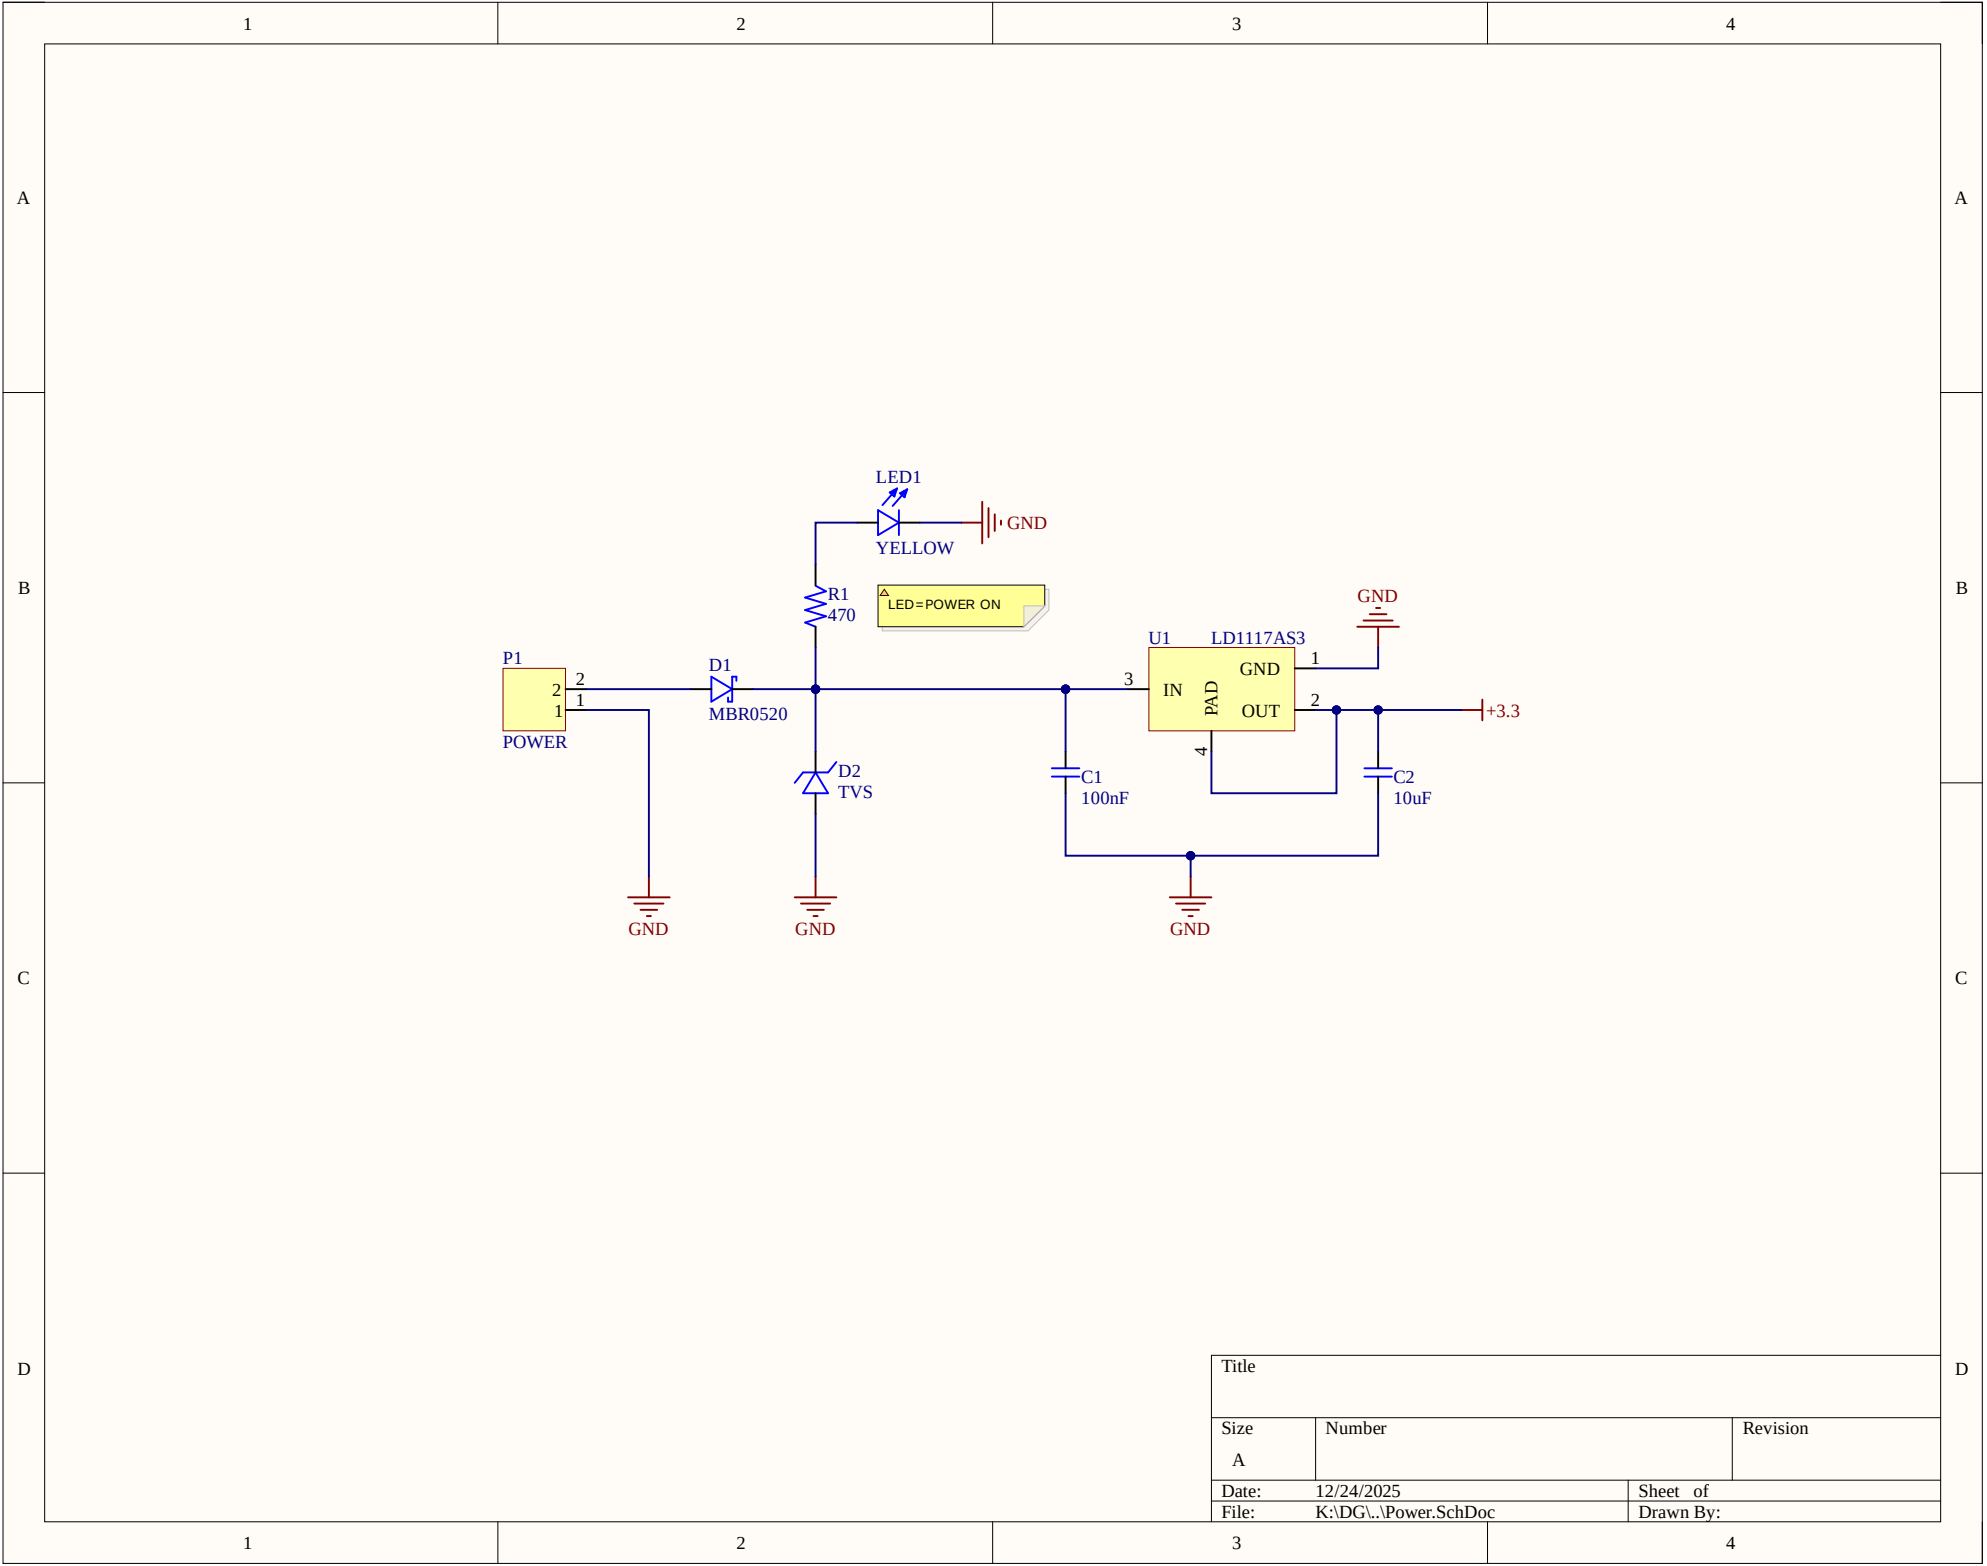
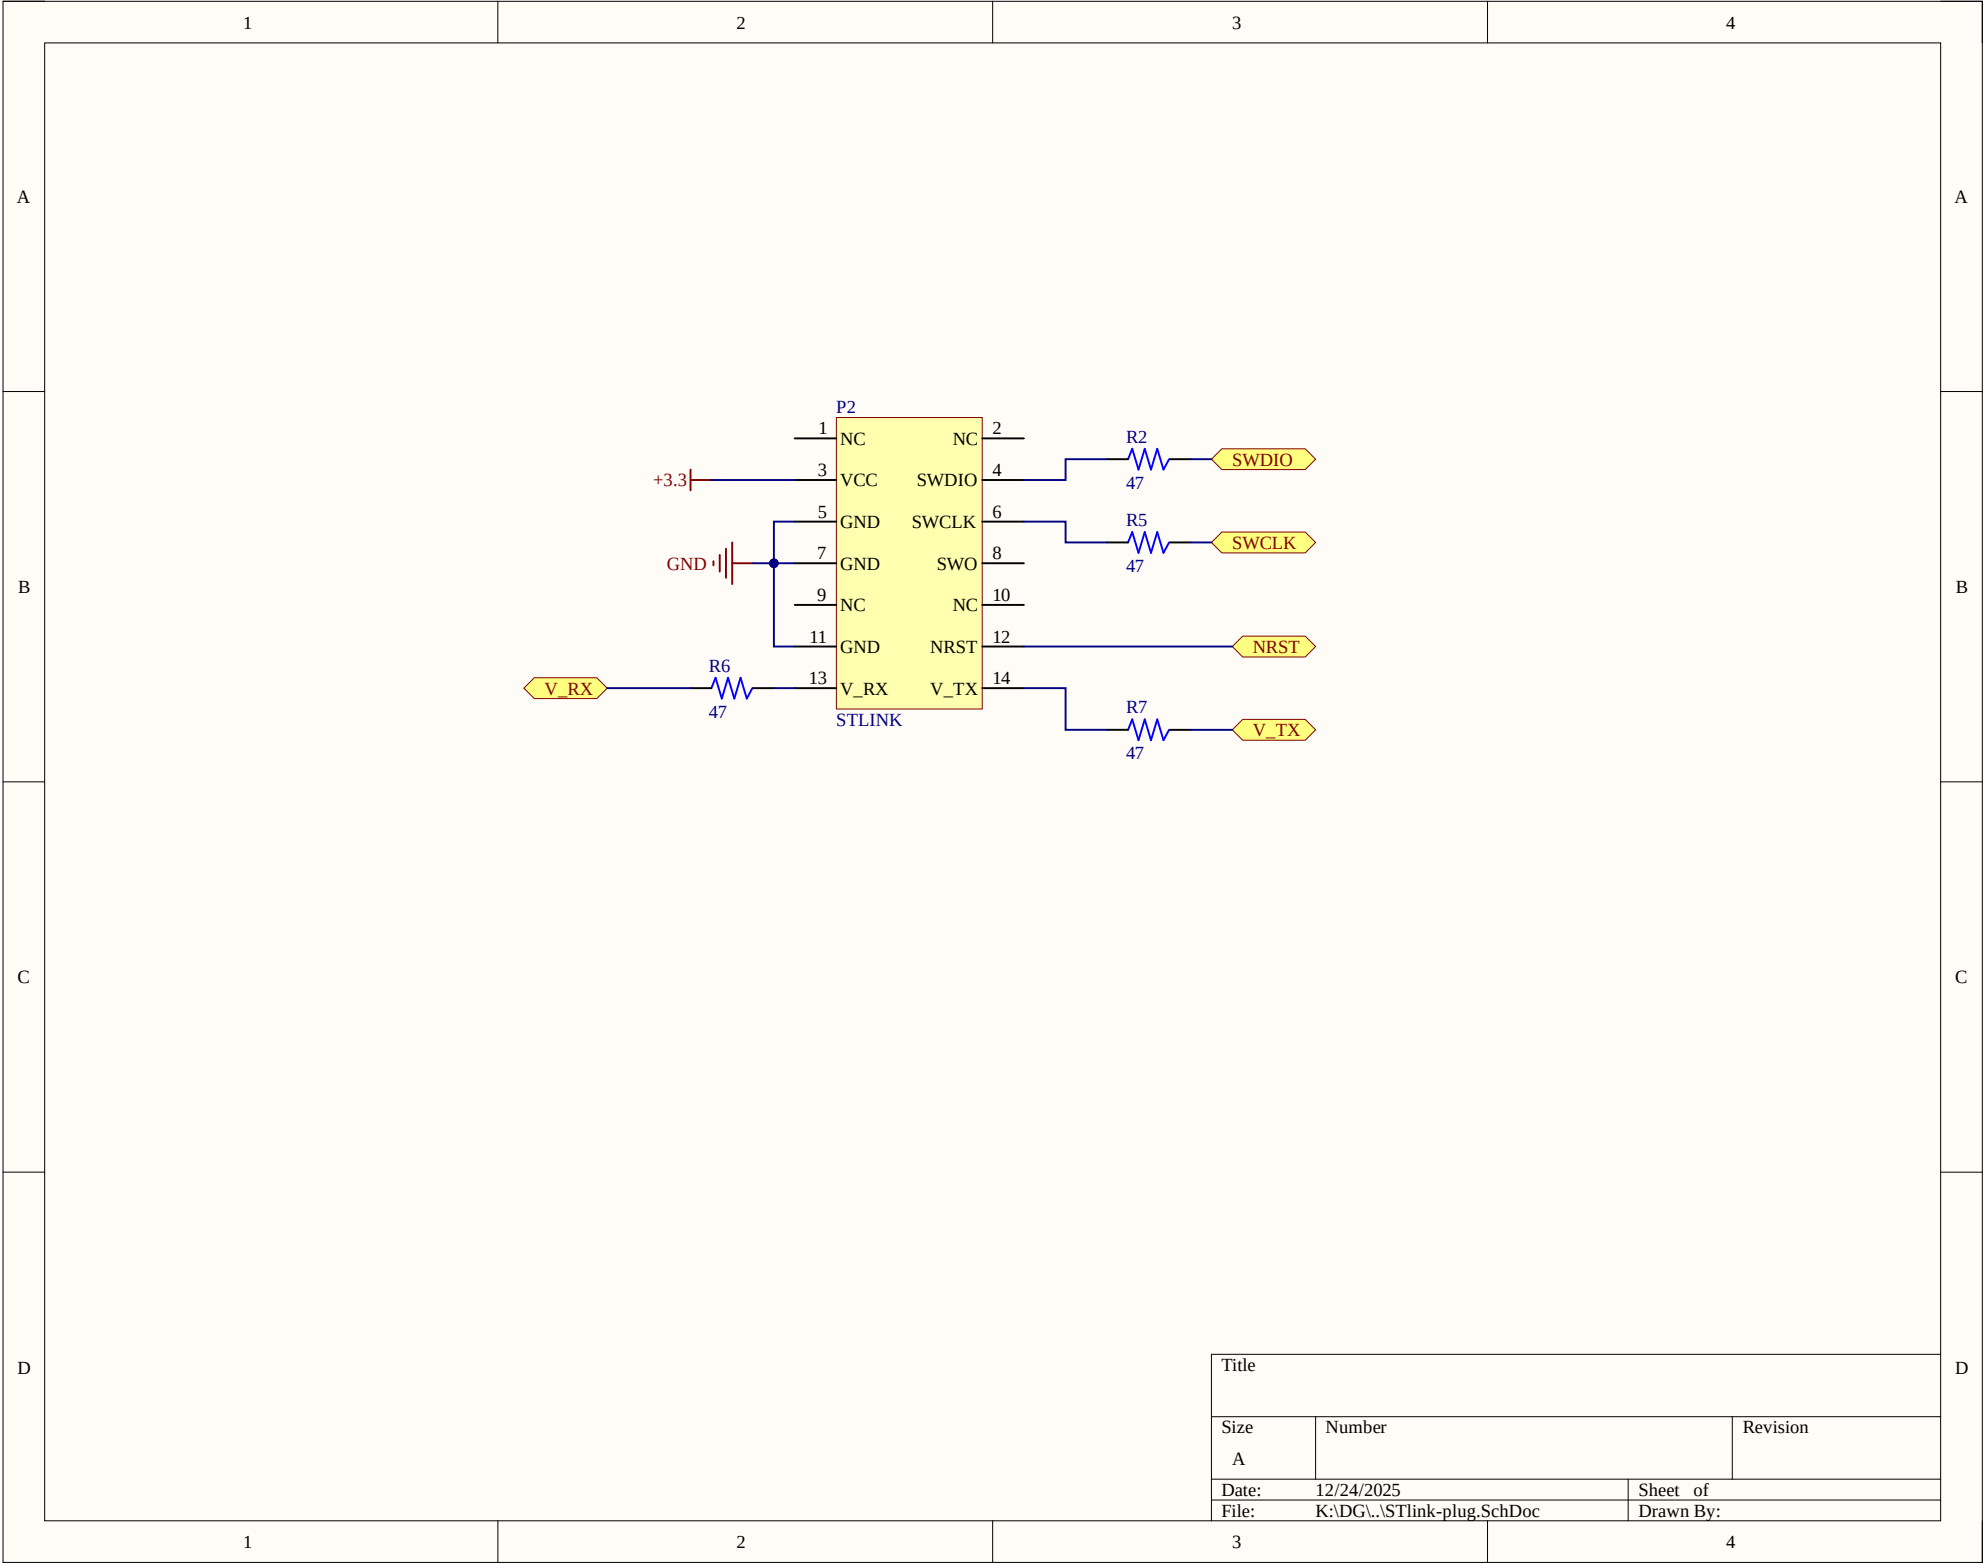
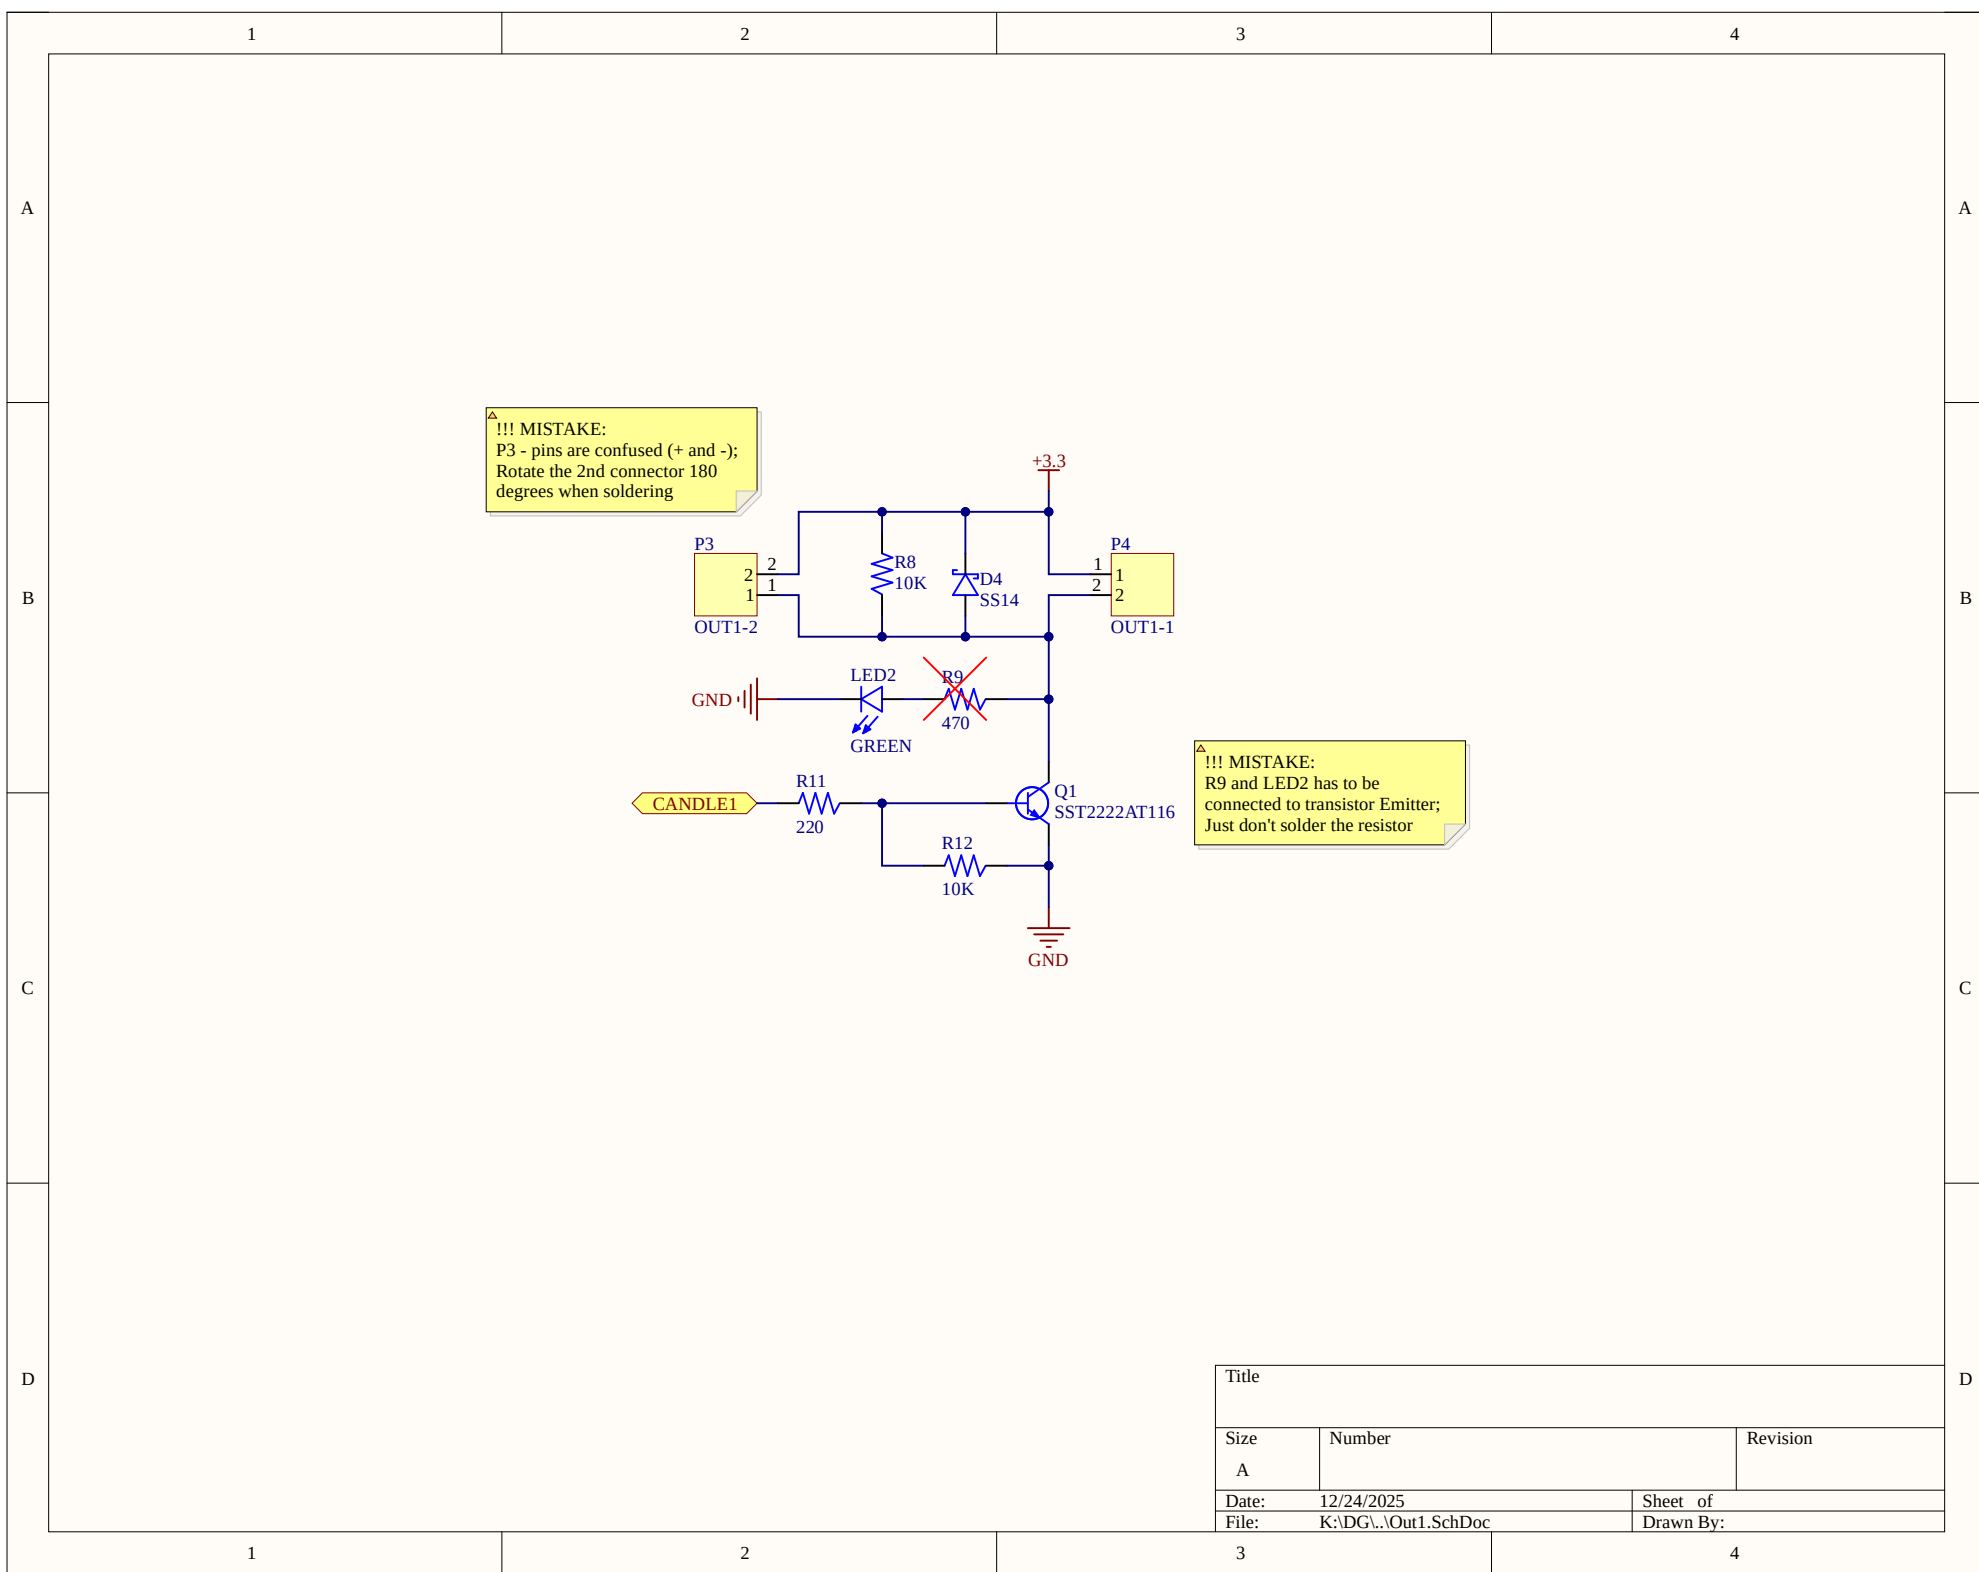
!!! MISTAKE:
P9 - pins are confused (+ and -);
Rotate the 2nd connector 180
degrees when soldering

!!! MISTAKE:
R22 and LED5 has to be
connected to transistor
Emitter;
Just don't solder the resistor
